**Re: Palomino Bay Addition – Drainage Study in support of the Preliminary Plat  
Second Review**

We have completed our 3<sup>rd</sup> review and offer the following comments. Please refer to the Denton County Subdivision Rules and Regulations dated July 2009 for drainage criteria; hereafter referred to as Criteria Manual.

## GRADING PLAN V

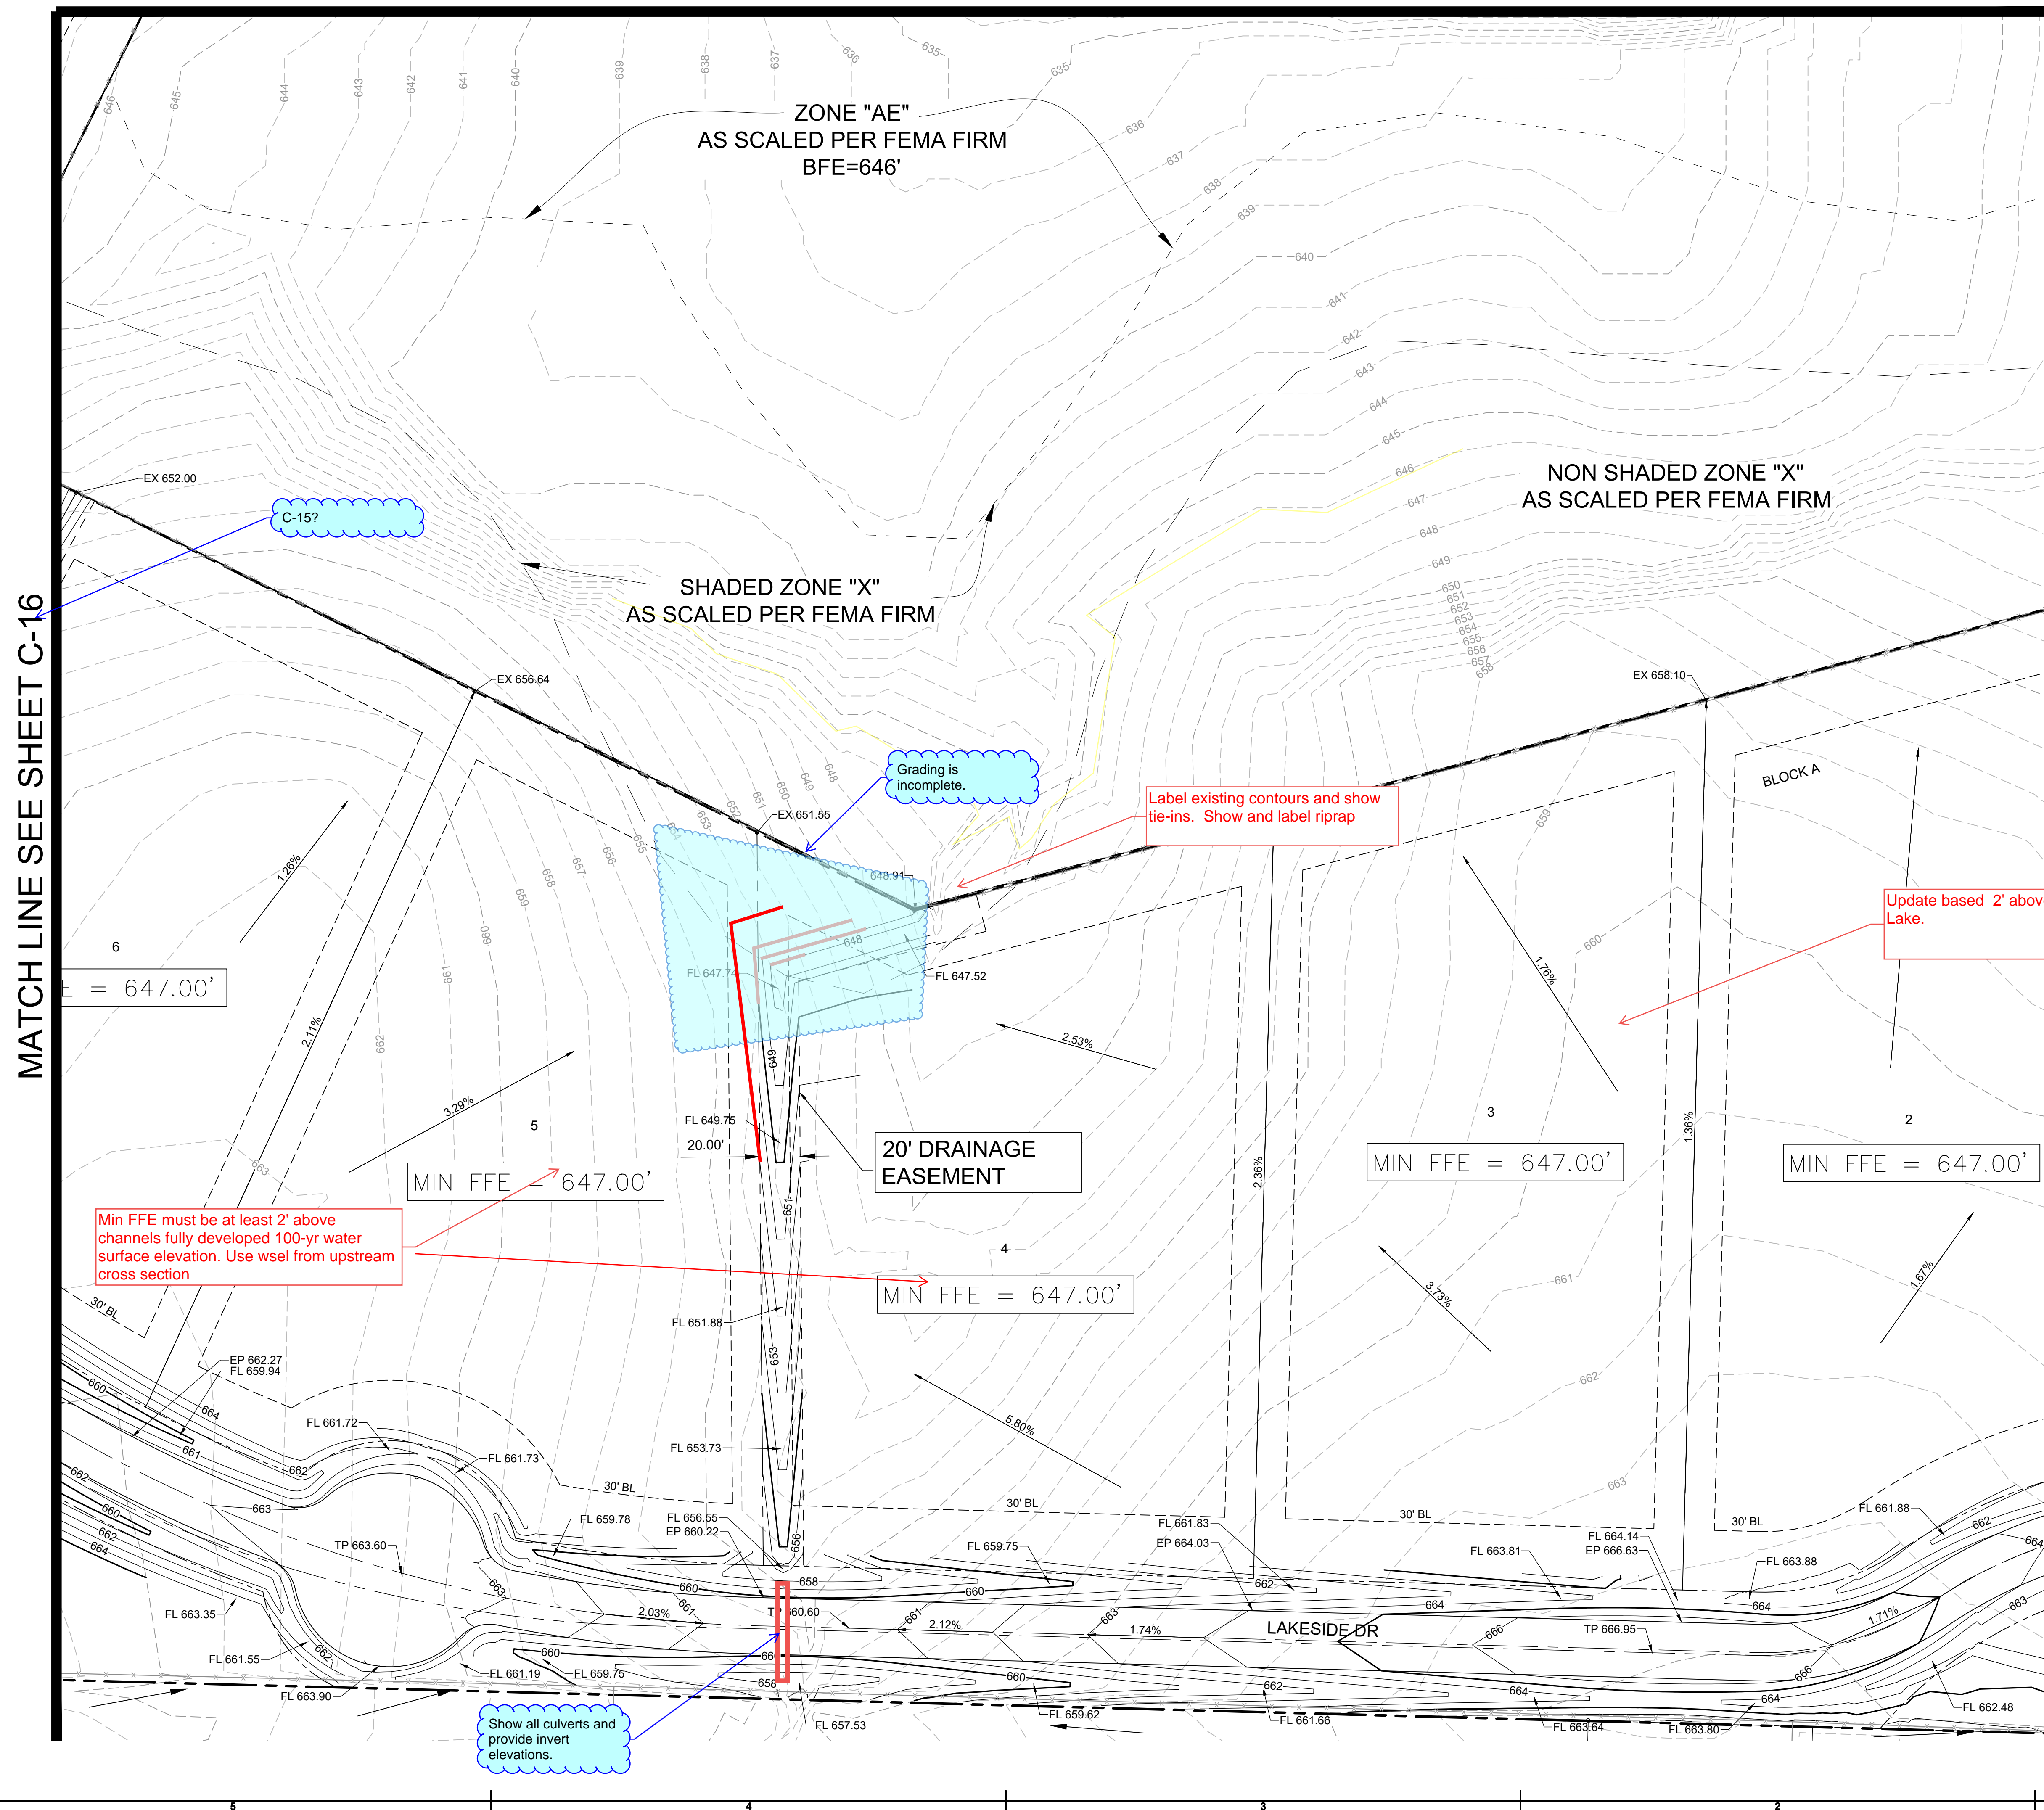
Min FFE must be at least 2' above channels fully developed 100-yr water surface elevation. Use wsel from upstream cross section

C-18?

Is a high point needed to keep the drainage within the Lakeview Drive ditch and stop it from bypassing to Lakeside Drive ditch?

Show all culverts and provide invert elevations.

Show stationing on all roadways.

Show all culverts and provide invert elevations.

Show all culverts and provide invert elevations.

**C-20**

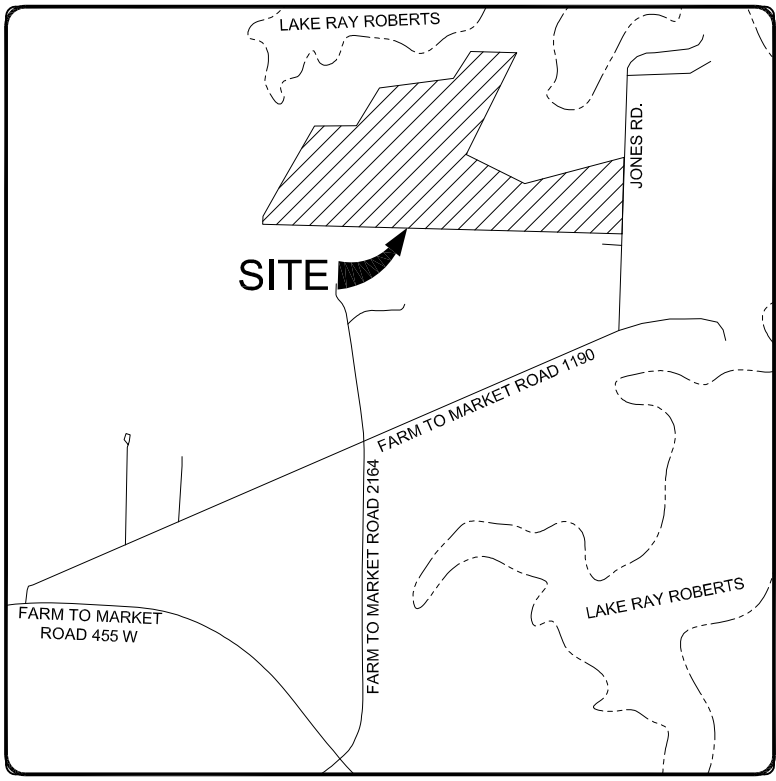
Update sheet number

Show and label ROW

Provide a RAS model to verify capacity of ditch. Roadside ditch must contain the fully developed 100-yr floodplain. Provide any additional DE as needed.  
If flow increased please provide pre- and post- analysis and demonstrate no adverse impacts.

Provide plan and profile for Culvert A and hydraulic calcs.

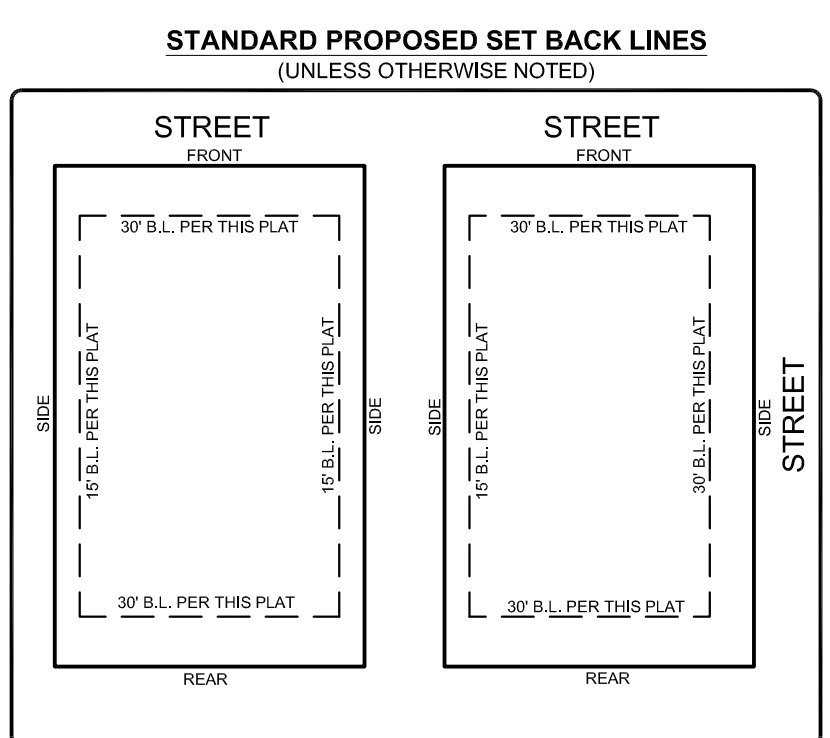
Update Min FFE for all lots based on the higher 2' above fully developed 100-yr wselev at Lake or at adjacent channel.

Provide floodplain easement 10' from fully developed lake water surface elevation

Label zone

Min FFE must be at least 2' above channels fully developed 100-yr water surface elevation. Use upstream cross section

Will need to coordinate width of all drainage easements once the Civil has finalized grading and confirmed width needed.

Show and label flowage easement

Call out Drainage Easement. Will need to coordinate width of all drainage easements once the Civil has finalized grading and confirmed width needed.

Will need to coordinate with Civil regarding potential need for drainage easement along roadway.

Min FFE must be at least 2' above channels fully developed 100-yr water surface elevation. Use upstream cross section
